**Re: City of West Linn Planning File Numbers DR-15-11/LLA-15-01;  
Applicant's Response to July 16, 2015 Incompleteness Determination**

RE: Application for proposed mixed-use development at the northwest corner of Tannler Drive and Blankenship Road.

The following are responses to completeness items provided by the City of West Linn in the July 16, 2015 completeness determination letter: (*City comments in italics*, Otak responses follow)

P1.3

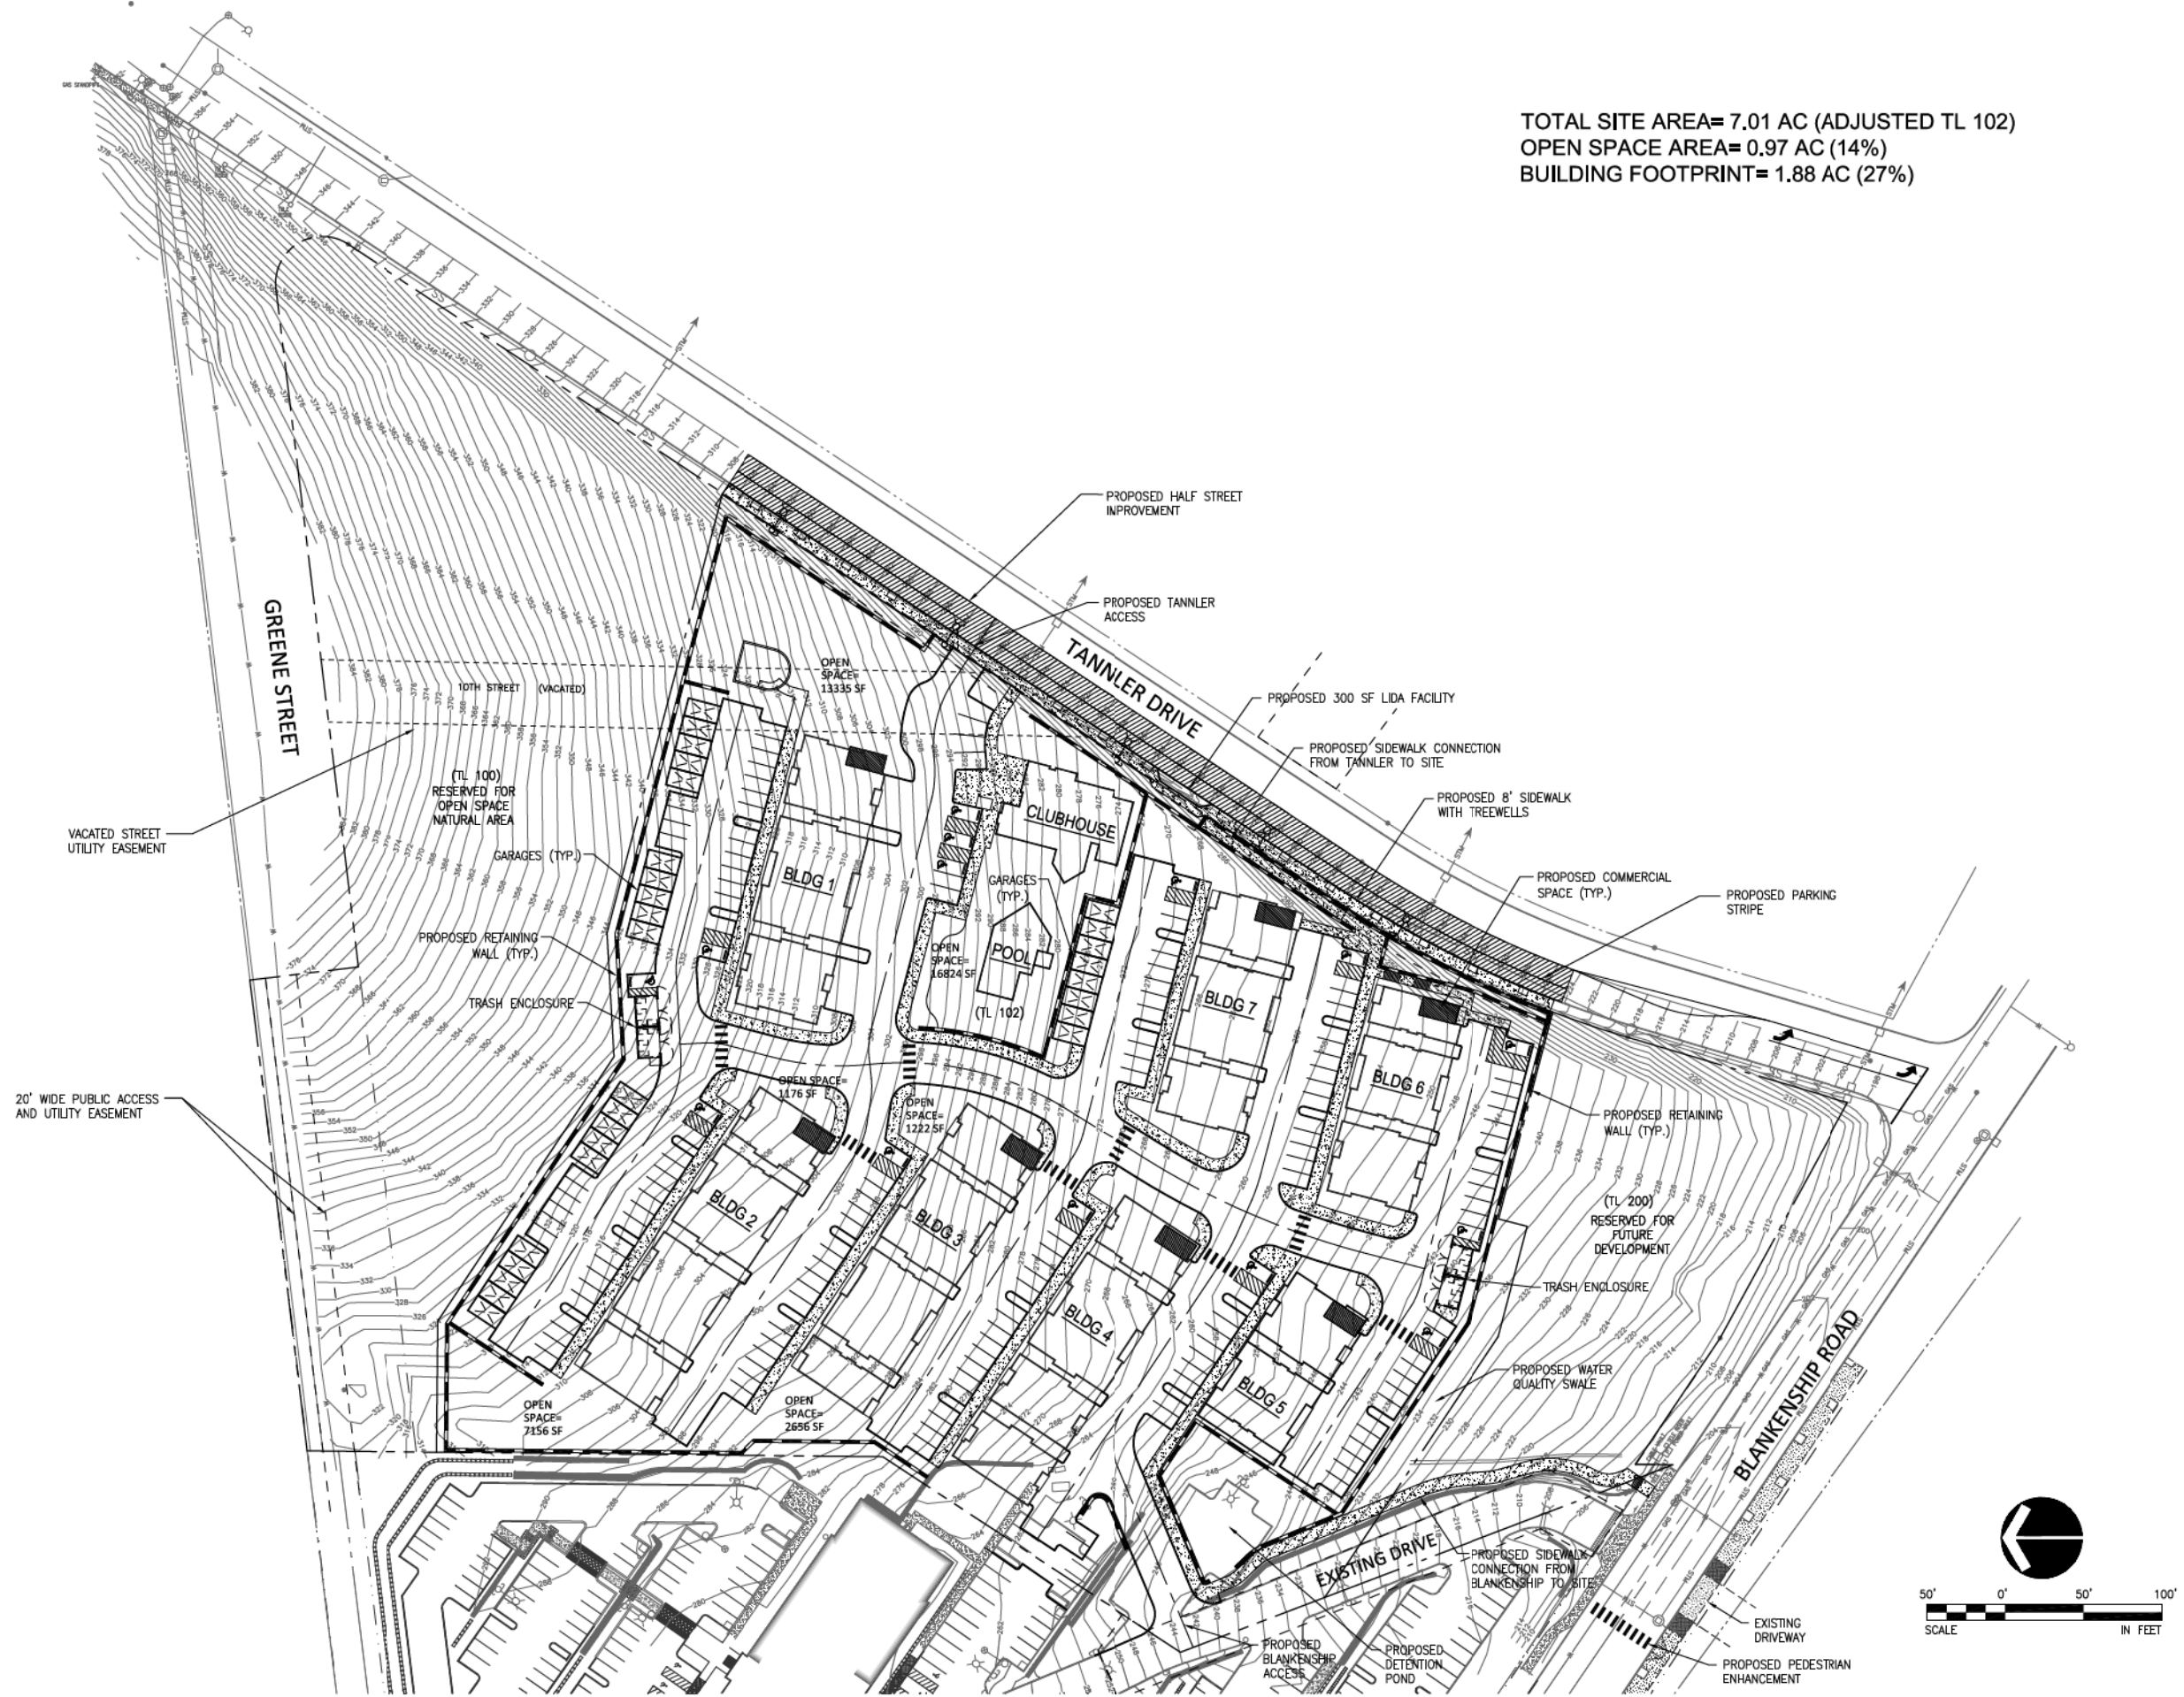
- a. *Site Analysis per CDC 55.110*  
i. 55.110(B)(6)(d) - *Site analysis must include areas shown on Map 17 as areas vulnerable to landslide.*

**Response:** Map 17 area shown on Sheet P1.3 in NE corner of the site. A reference to Map 17 and the project area has been added to Appendix F (Geotechnical Report) of the application.

Plotted: Jul 20, 2015 - 11:55am bndb L:\Projects\17100\17122\Draw\17122P21.dwg Layout Name: P2.1

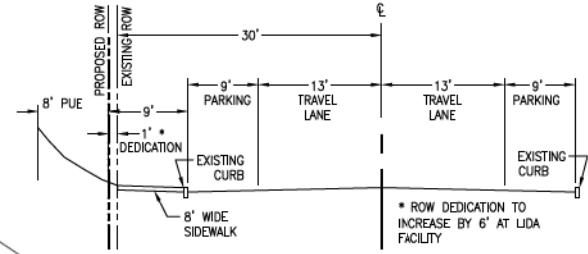
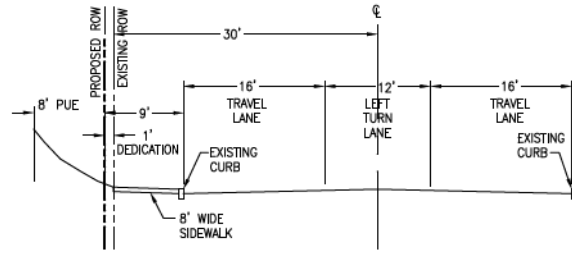
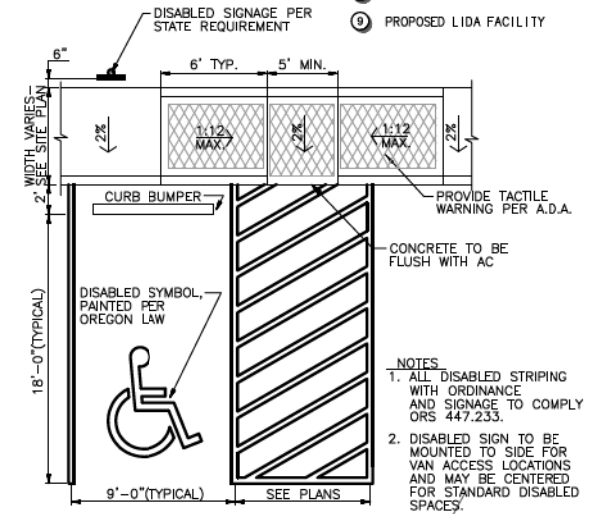
- d. Please correct conflicting information regarding right-of-way dedication along Tannler Dr.: two-feet is proposed on page 29 of the submittal but a 1-foot dedication is shown on the site plan (P2.1).*

*f. Please correct conflicting information regarding the width of parking and travel lanes along Tannler Dr.: page 29 of the submittal mentions an 11-foot parking lane and 13-foot travel lane; however, an 8-foot parking lane and 14-foot travel lane are shown on the site plan (page P1.1) and a 9-foot parking lane and 13-foot travel lane are shown on page P2.1.*

*k. Please correct the striping plan on Tannler Dr. to terminate the on-street parking at an appropriate distance from the proposed left turn lane.*

**Response:** Updated narrative to reference 1-foot dedication to match site plan (P2.1).

**Response:** Updated narrative to reference parking (8') and travel lane (13') widths on Tannler Drive to match site plan (P2.1).

**Response:** Updated striping and labeling for on-street parking on Tannler Drive on sheet P2.1.

17122 P17122P40  
Project No. Drawing No.  
**P4.0**  
Sheet No.  
© Otak, Inc. 2015

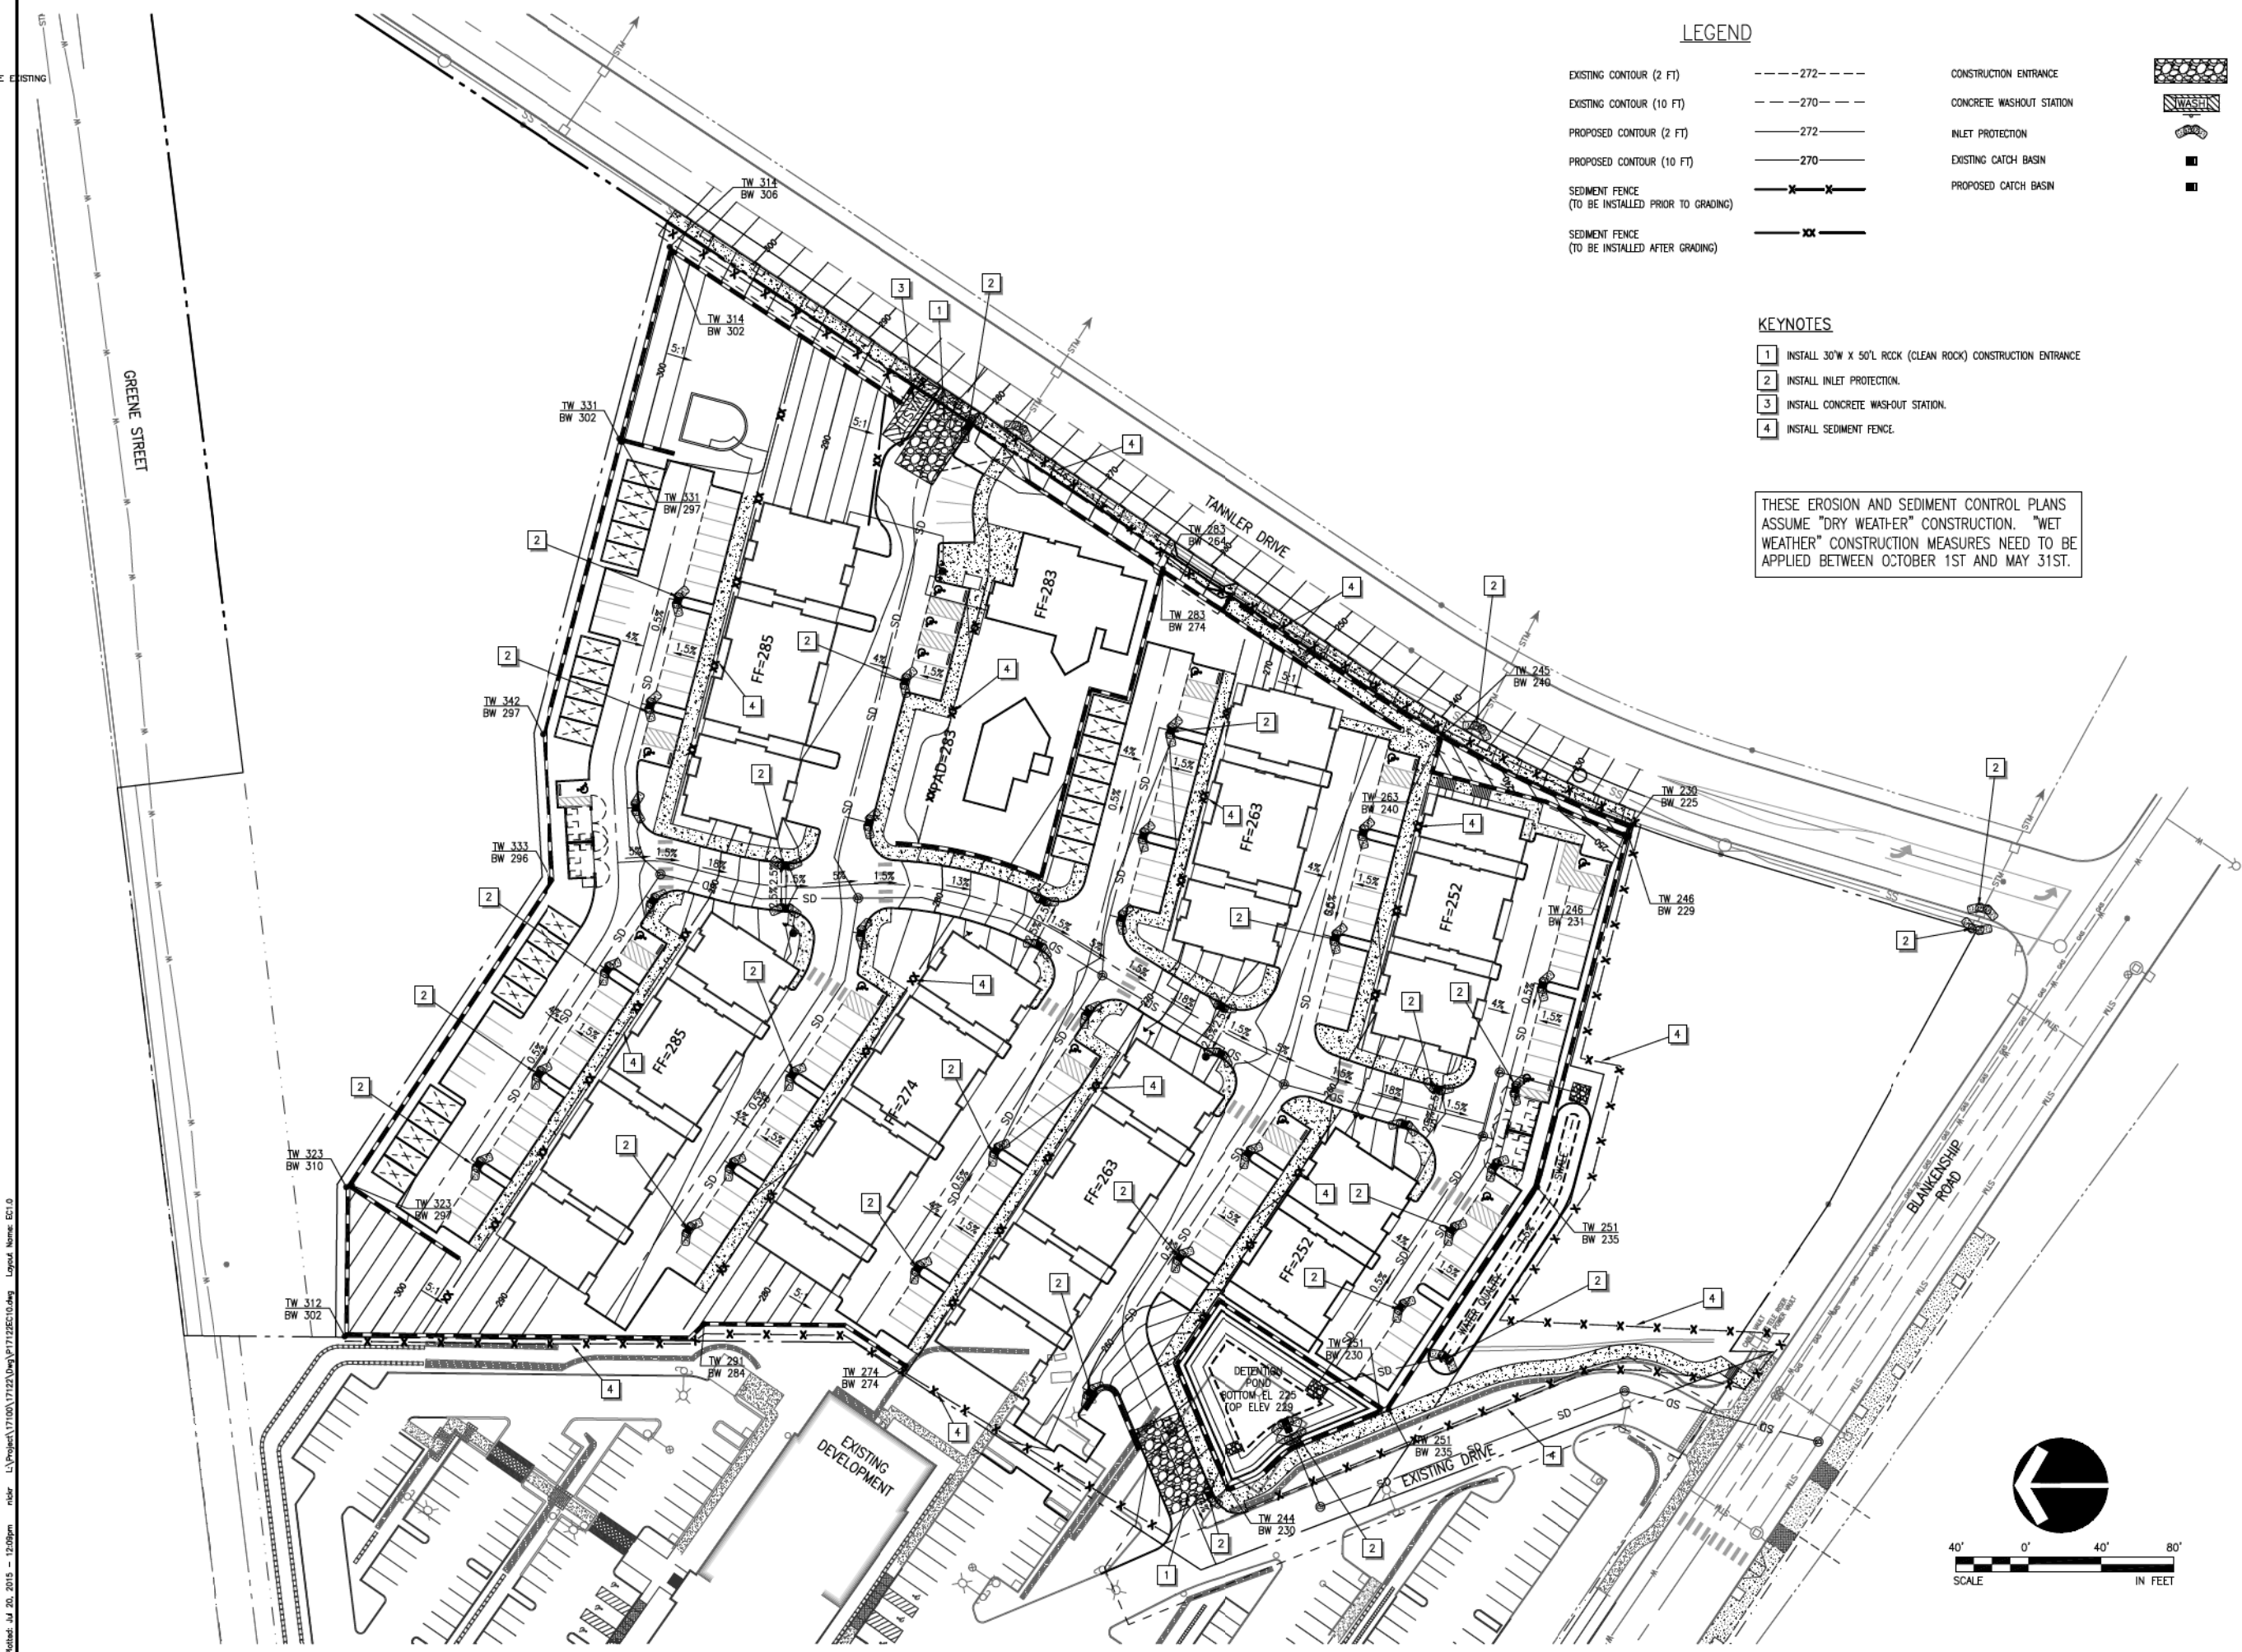
*h. Please show the water meter in a public easement or in the public right-of-way.*

*i. Please show a manhole at the connection of the sanitary sewer.*

**Response:** Added to sheet P4.0.

**Response:** Added to sheet P4.0.
